Axis Knitwears Ltd (relocated)

Mawna, Sreepur, Gazipur
(24.253515N, 90.399563E)
17th June & 11th August 2021

Buildings Information

Poorly anchored tin shed and extended column on roof

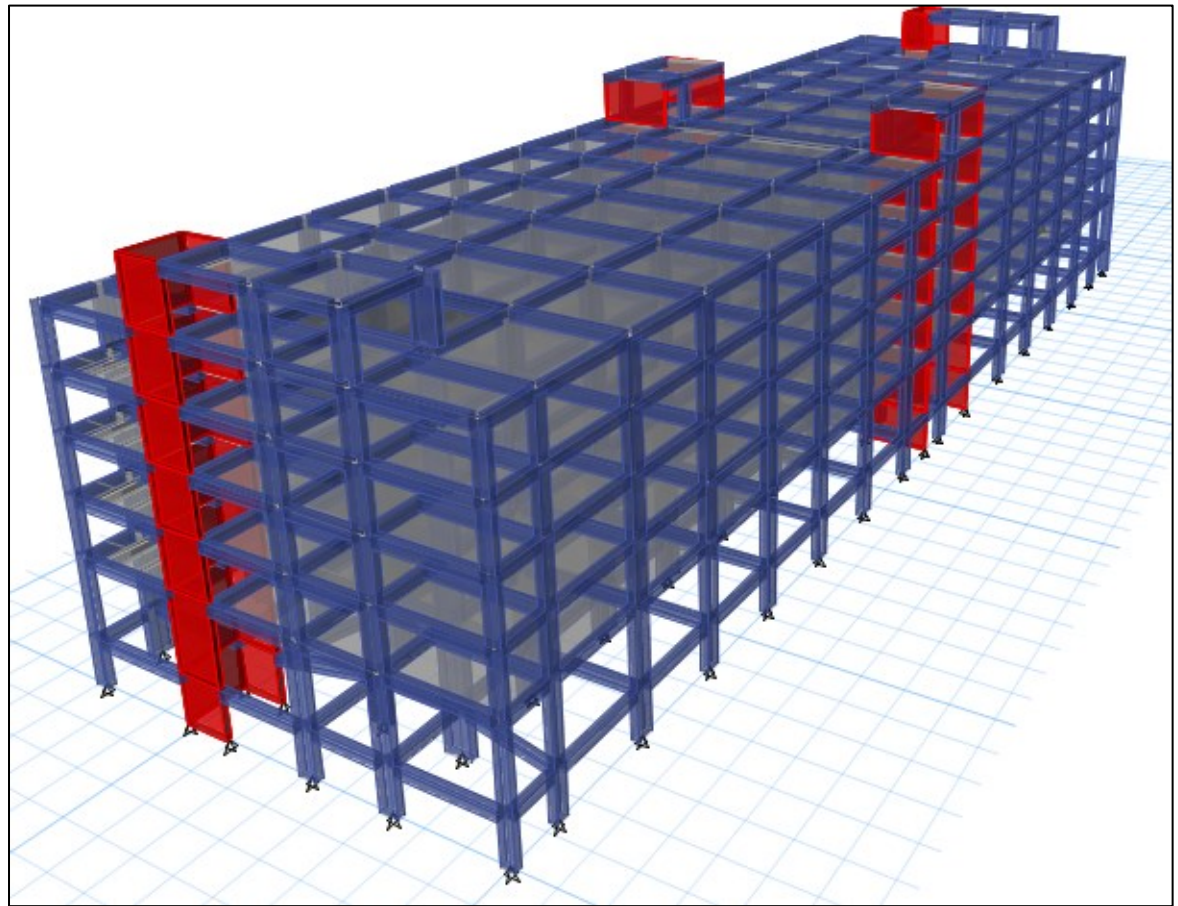
On roof, full height columns have been constructed which has not been incorporated in FEA model and as-built drawing. Moreover, in FEA model all staircase top has been assigned with RC Slab which does not match with existing condition. Factory engineer is required to revise the FEA model for roof top RC columns as per onsite condition and replace the tin shed with RC slab/engineered structure as per the FEA model and update the design documents accordingly.

Item No.	Observation	Recommended Action Plan	Recommended Timeline
01	Poorly anchored tin shed and extended column on roof (Main Building)	Factory engineer is required to revise the FEA model for roof top RC columns as per onsite condition and update the design documents in compliance with section 1.9.1 (Part-6, BNBC-2006).	6-weeks
02	Poorly anchored tin shed and extended column on roof (Main Building)	Factory engineer is required to replace the tin shed with RC slab/engineered structure as per the outcome of FEA analysis and update the design documents accordingly.	6-months
03	Design report needs to be revised. Building-2 & 3 (Generator and Sub-station Room)	Building engineer to update the design document including a design report, and a set of structural drawings in compliance with section 1.9.1 (Part-6, BNBC-2006).	6-weeks
04	Design report needs to be revised. Building-2 & 3 (Generator and Sub-station Room)	Complete implementation of any remedial works deemed necessary by the assessment report.	6-months

Combined footing F4 between Building-2 & 3 (Generator & Sub-station)

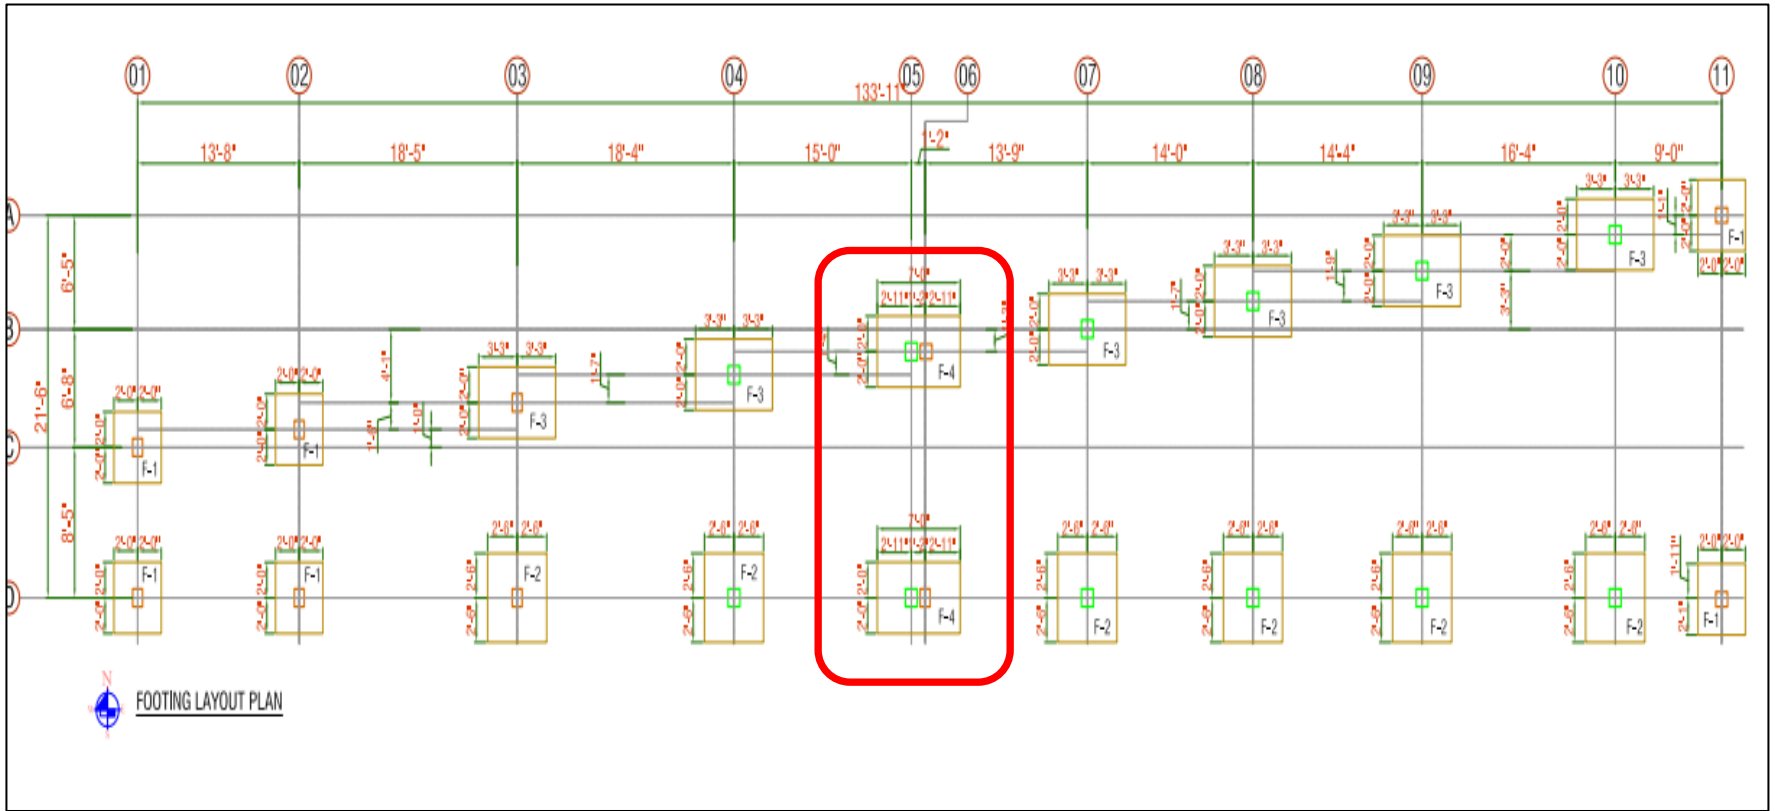
In expansion joint between Building-2 & 3 (Generator & Sub-station), footing type F4 is being share between them according to drawing. But in foundation adequacy check axial load from single column has been considered. Factory engineer is required to check the adequacy of footing F4 considering loads from both columns and incorporate them in design report.

Structural wall reinforcement details :Building-4 (Fire Reservoir & Compressor Room)

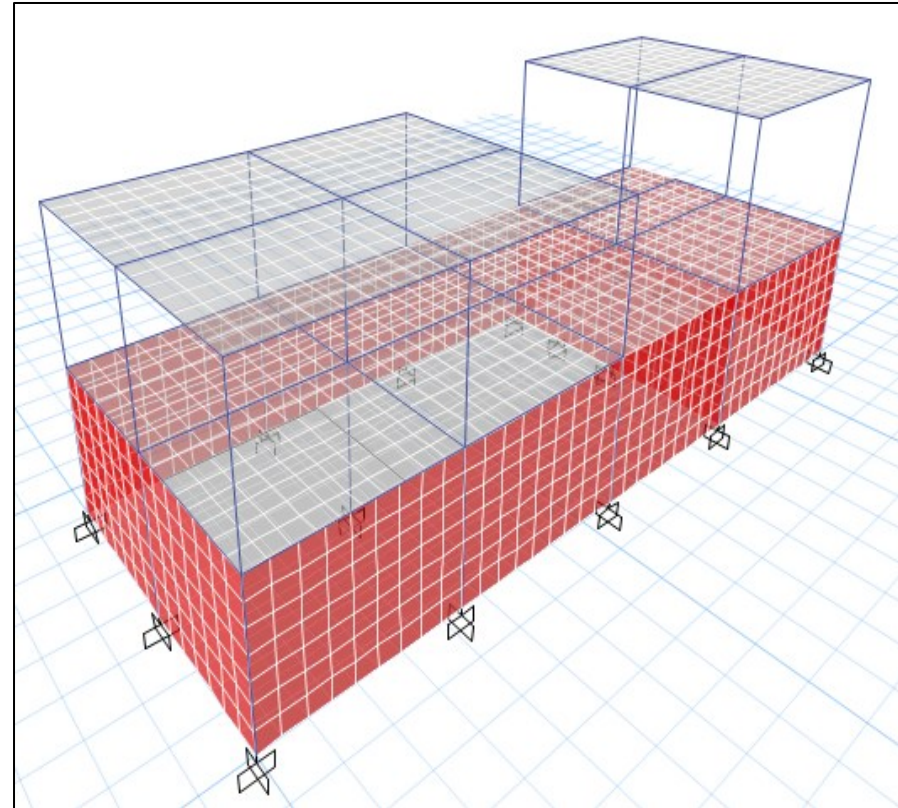
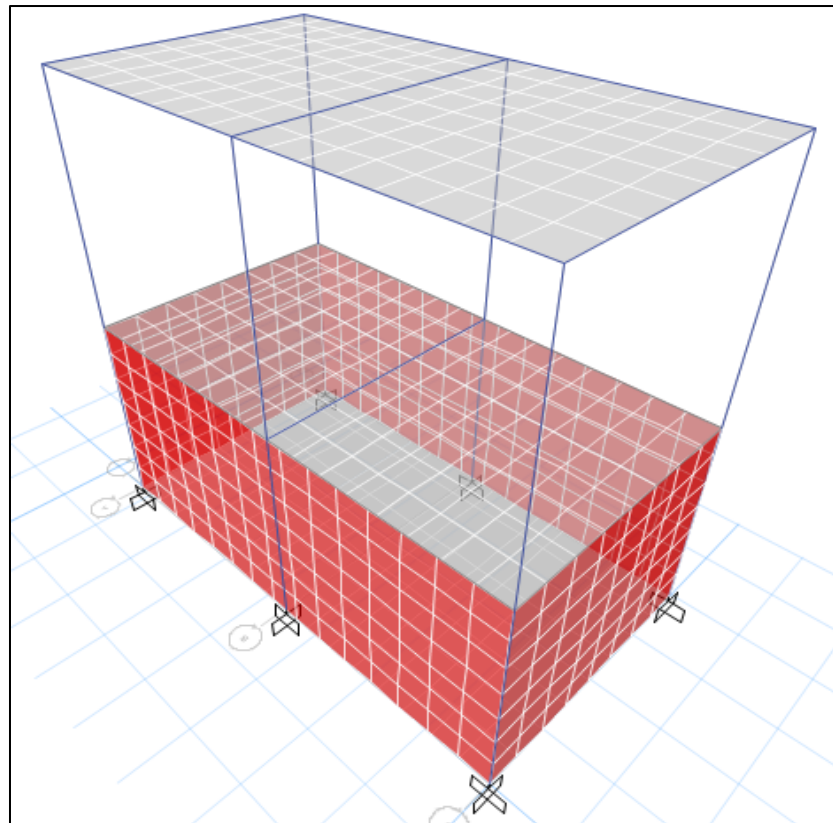
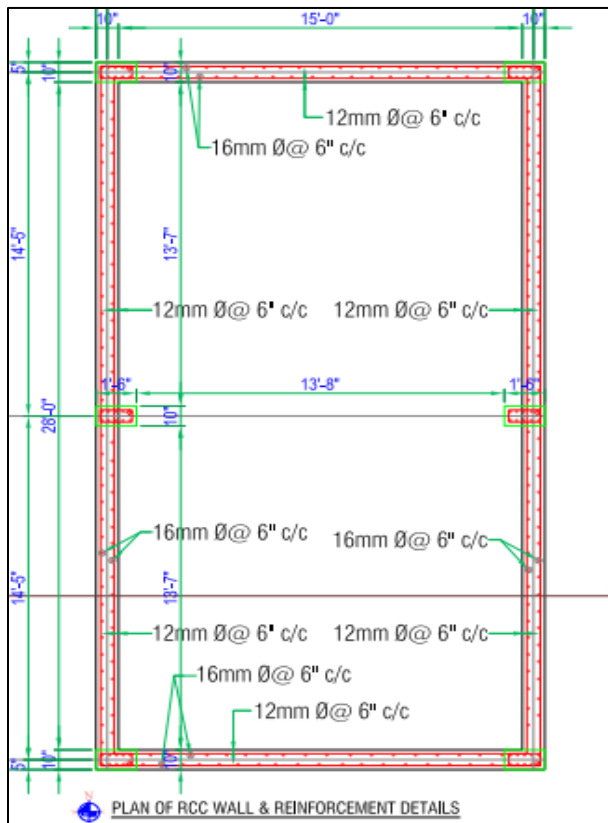
These structures are combination of moment resisting frame and structural wall. These walls have been incorporated in FEA model and reinforcement details are also provided in drawing. However in design report no information has been provided regarding the adequacy of these structural walls. Factory Engineer is required to incorporate the adequacy check in design report.

Item No.	Observation	Recommended Action Plan	Recommended Timeline
05	Design report needs to be revised. Building 4&5: (Fire Reservoir & Compressor Room) & (Domestic Reservoir & Boiler Room)	Building engineer is required to incorporate the adequacy check of structural walls in design report update the design document including a design report, and a set of structural drawings in compliance with section 1.9.1 (Part-6, BNBC-2006).	6-weeks
06	Design report needs to be revised. Building 4&5: (Fire Reservoir & Compressor Room) & (Domestic Reservoir & Boiler Room)	Complete implementation of any remedial works deemed necessary by the assessment report.	6-months
07	Lack of stability. (Shed-1)	Building engineer is required to check the adequacy of the roof shed for uplift and lateral forces or replace with the engineered sheds.	6-weeks
08	Lack of stability. (Shed-1)	Carry out remedial works where necessary.	6-months
